SUBJECT: Big Rock Point, "Big Rock Point License Termination Plan," Revision 3

Big Rock Point
Dockets 50-155 and 72-043
License No. DPR-6

Big Rock Point License Termination Plan Revision 3 Summary

Big Rock Point License Termination Plan Revision Matrix

**Figure 1-1. Big Rock Point ISFSI Location In Relation
To The Site Map At The Time Of LTP Submittal**

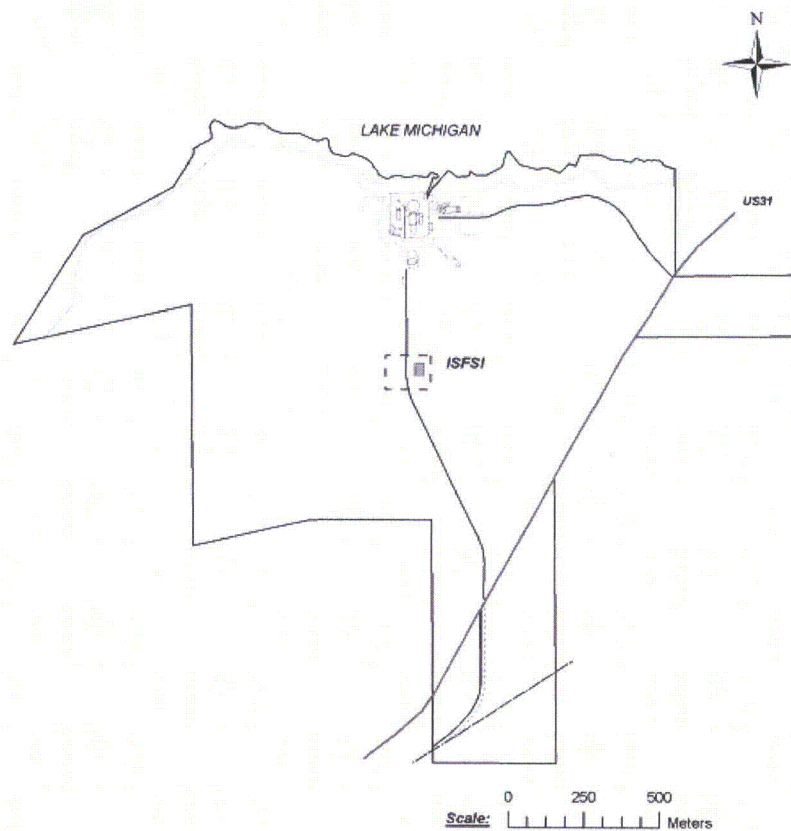
1.7	1-10	Updated the contact information for the LTP.	New contact for BRP ISFSI LTP.
Fig. 1-1	1-11	Changed the Figure title from “Big Rock Point Owner Controlled Area” to “Big Rock Point ISFSI Location In Relation To The Site Map At The Time Of LTP Submittal.”	Revised the title of the figure to reflect the completion of the first phase of decommissioning.
Fig. 1-2	1-12	Added Big Rock Point ISFSI Non-Impacted Land Areas Map.	Added the map to provide a visual depiction of the Entergy Palisades LLC BRP ISFSI property boundary in relation to the Consumers Energy property boundary.
Fig. 1-3	1-13	Added ISFSI Land Survey Map.	Added the survey map as a reference.

Figure 8-1. Big Rock Point Site Boundary Map

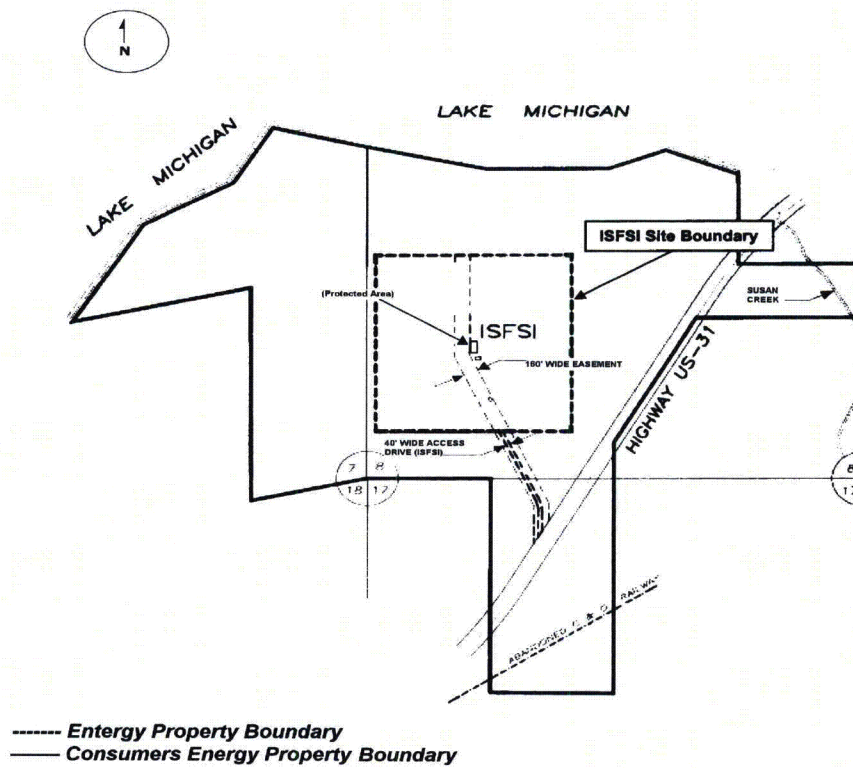
8.7	8-27	Added the words “the final phase of” and deleted “of BRP Nuclear Plant.”	This revision reflects the final phase of decommissioning.
Figure 8-1	8-29	Revised the figure.	Removed the former power reactor facility and added the ISFSI site boundary.
Figure 8-2	8-30	Replaced the figure.	Replaced the figure with a figure containing the property survey of the ISFSI.
Figure 8-3	8-31	Renumbered the figure.	The figure was previously Figure 8-2.
Figure 8-4	8-32	Added new figure	Figure 8-4 added to show location of the ISFI relative to Figure 8-3.

Figure 8-5. Land Use Within Five Miles of Big Rock Point

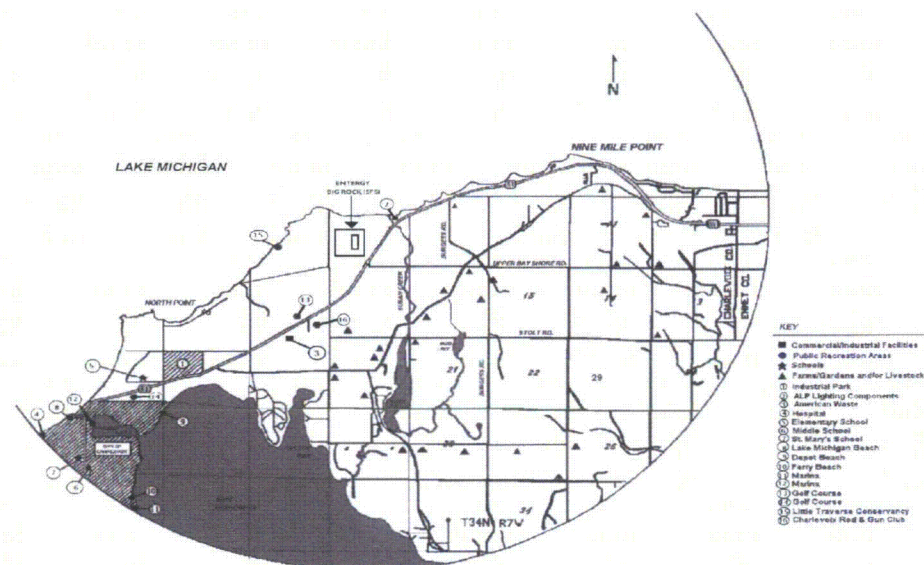
Section	Page	Revision	Basis
Figure 8-5	8-33	Revised and renumbered the figure.	The figure was previously Figure 8-3. Revised the figure to remove the Consumers Energy property boundary and add the Entergy ISFSI property boundary. Updated the key listing.
Figure 8-6	8-34	Renumbered the figure.	The figure was previously Figure 8-4.
Figure 8-7	8-35	Revised and renumbered the figure.	The figure was previously Figure 8-5. Updated the figure with the most recent information from the United States Geological Survey (USGS).
Figure 8-8	8-36	Revised and renumbered the figure.	The figure was previously Figure 8-6. Revised the figure to remove the Consumers Energy property boundary and add the Entergy ISFSI property boundary.
8.8	8-37, 8-38, 8-39	Revised the section.	Revised the references to reflect the revisions in the chapter.
